DOMINION NUCLEAR CONNECTICUT, INC.
MILLSTONE POWER STATION UNIT 2
CORE OPERATING LIMITS REPORT, CYCLE 18

CORE OPERATING LIMITS REPORT, CYCLE 18

TECHNICAL REQUIREMENTS MANUAL
APPENDIX 8.1
CORE OPERATING LIMITS REPORT, CYCLE 18

FIGURE 2.5-1
AXIAL SHAPE INDEX vs.
PERCENT OF ALLOWABLE POWER LEVEL

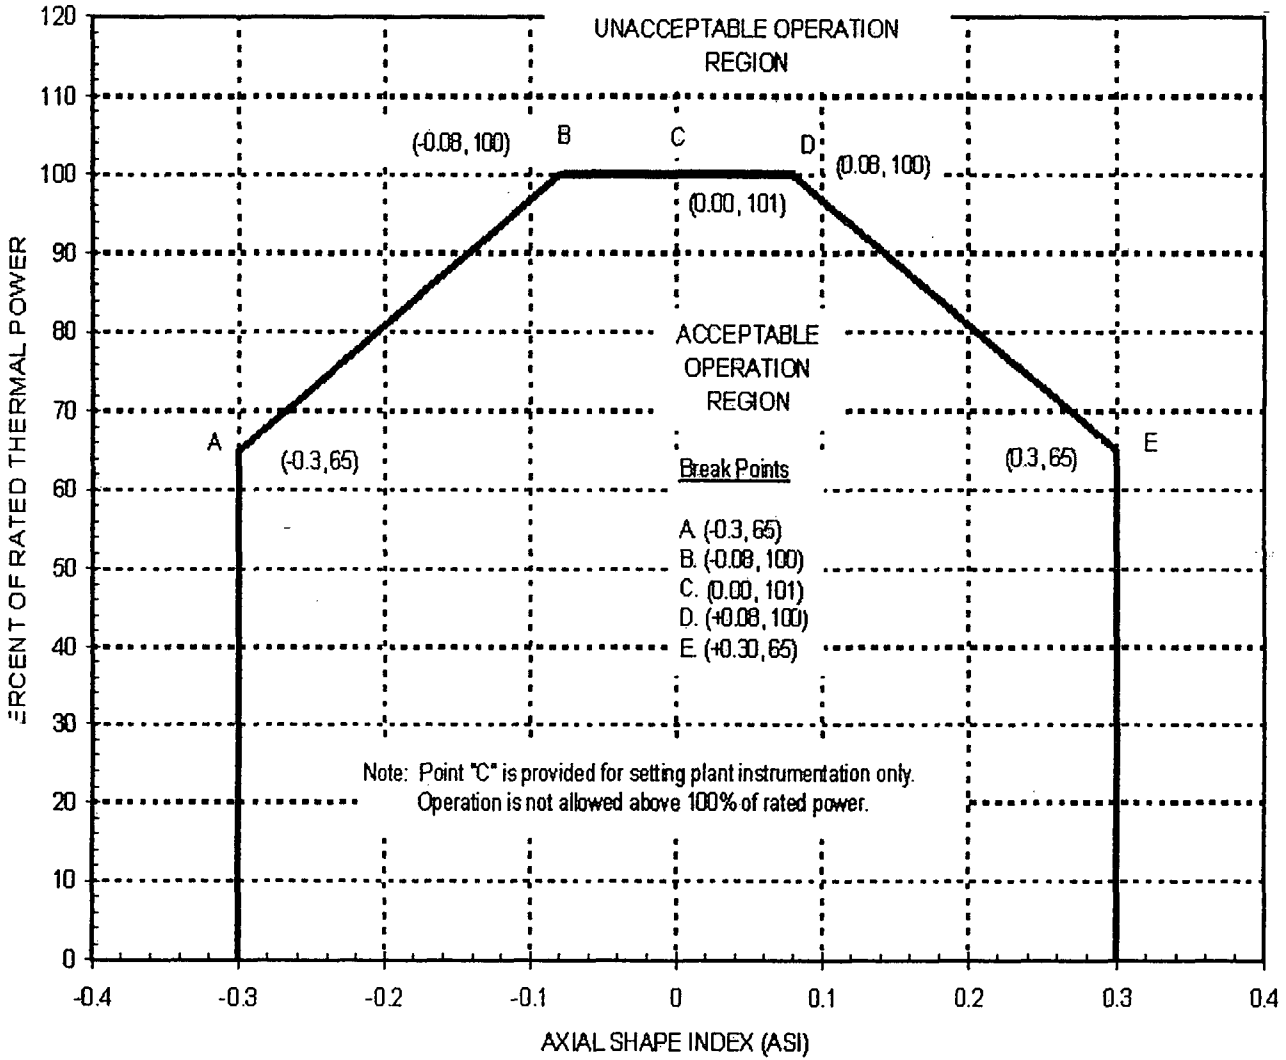
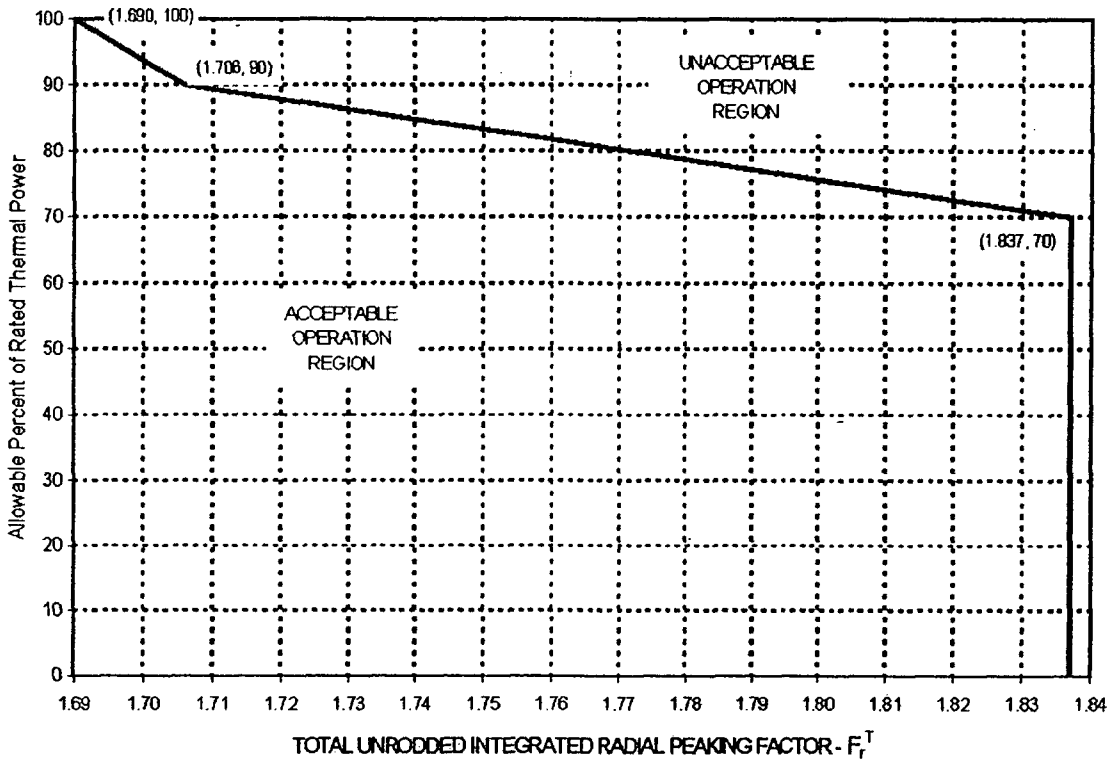
The Millstone Power Station Unit 2 COLR has been revised to incorporate changes for Cycle 18 operation. The changes consist of cycle number changes in the headers and a typographical correction to Reference 3.3. Additionally, coordinate "C" on the Axial Shape Index, Figure 2.5-1, was changed from (0.04, 101) to (0.00, 101), and this change was determined to be acceptable with regard to the safety analysis. No change was required to the operating limits in order to produce acceptable safety analysis results.
